CENTRAL AVENUE CONNECTOR TRAIL

30% Design Project: Phase I—Addison Road Segment

THE MARYLAND-NATIONAL CAPITAL PARK AND PLANNING COMMISSION
PRINCE GEORGE'S COUNTY PLANNING DEPARTMENT

JANUARY 2017

ROADWAY PLAN		
SCALE 1"=20'	DATE AUGUST 2016	CONTRACT NO. T.B.D.
DESIGNED BY JCW/WRW	COUNTY PRINCE GEORGES	
DRAWN BY WRW	LOGMILE MD 214 0.680-1.640	
CHECKED BY RJA/RJG		
F.A.P. NO. T.B.D.		
DRAWING NO. PS09 OF 10	SHEET NO. 15 OF 26

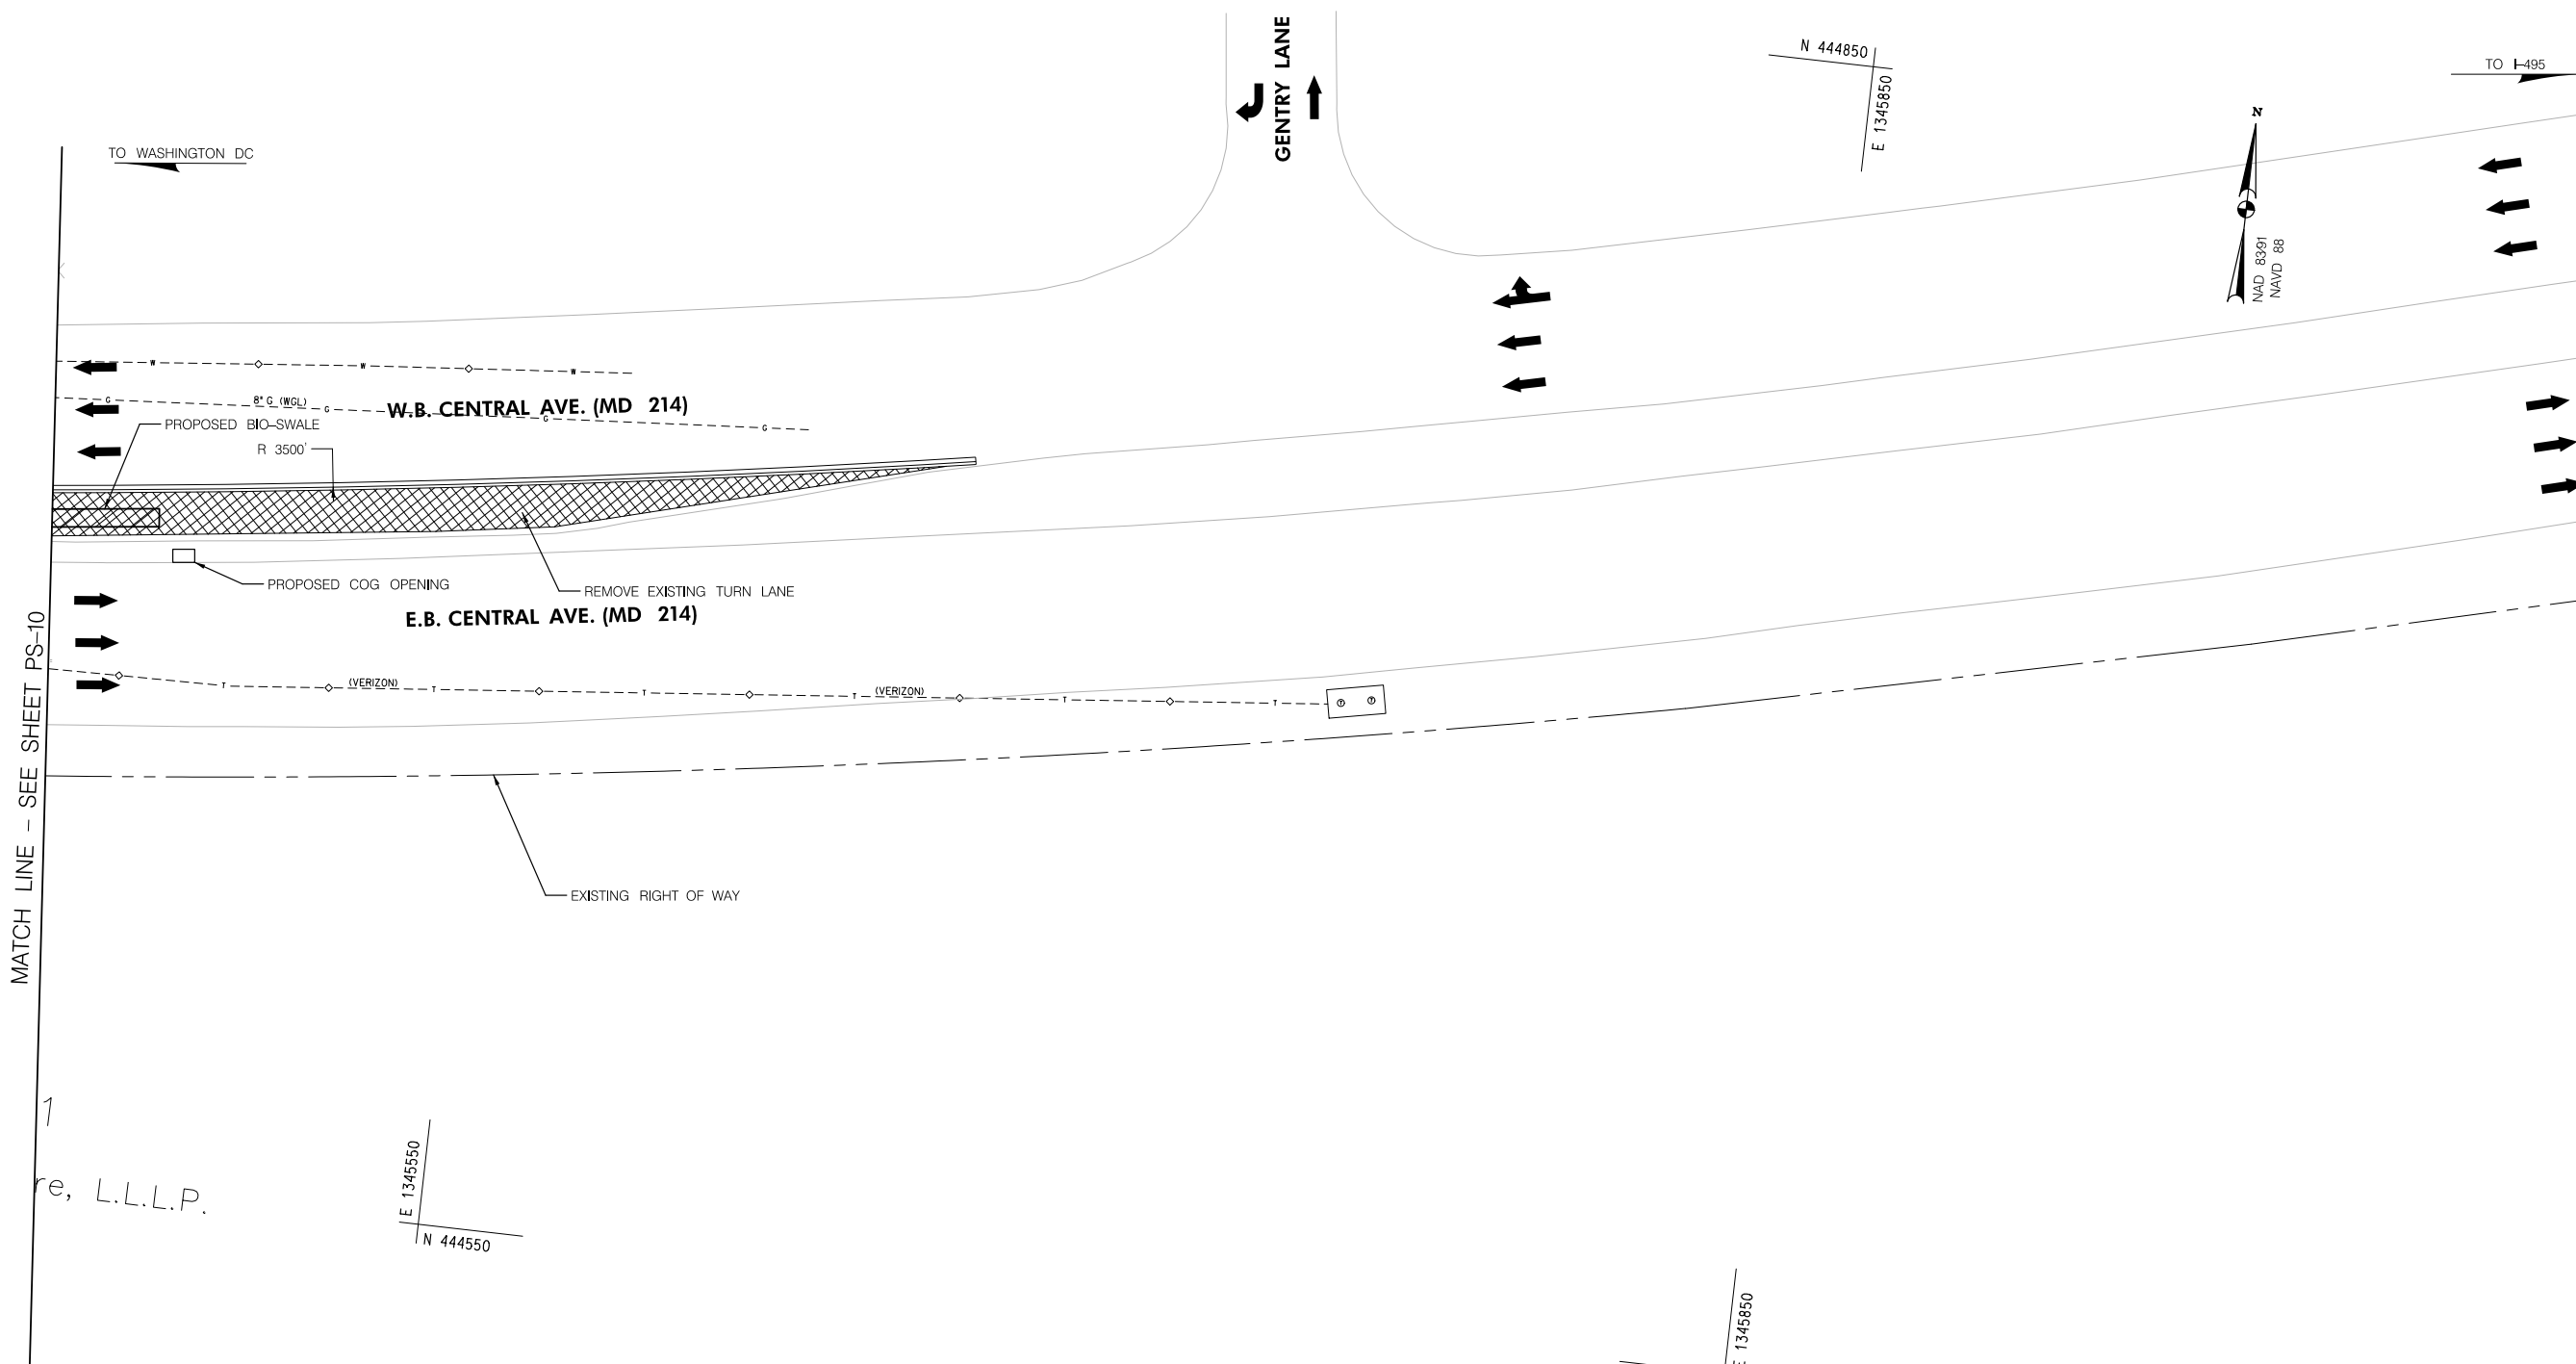
21	General	CONS/Civil	Provide details at the existing/proposed driveways, ramps crossings, junction with the trail. Provide stop signs for pedestrians.	Additional details will be provided during final design.	
22	Sheet 15 of 25	CONS/Civil	Is there planned signage at the end of the trail or median at Central Avenue/Pepper Mill Drive intersection?	Signage will be developed as part of the next submission.	
23	General	Parking (PARK)	Confirm that tactile areas are shown on curb ramps. Curb ramps and flares are not clearly marked.	To meet SHA ADA Guidelines Detectable Warning Surfaces will be installed. Details of the ADA ramps will be provided at the next submission.	
24	General	PARK	All drainage grates and other obstructions such as fences should be located a minimum of two feet from edge of path.	To be reviewed/revised in next submission.	
25	General	PARK	All curb radii should be reduced to the minimum possible.	Curb radii will be further evaluated during final design.
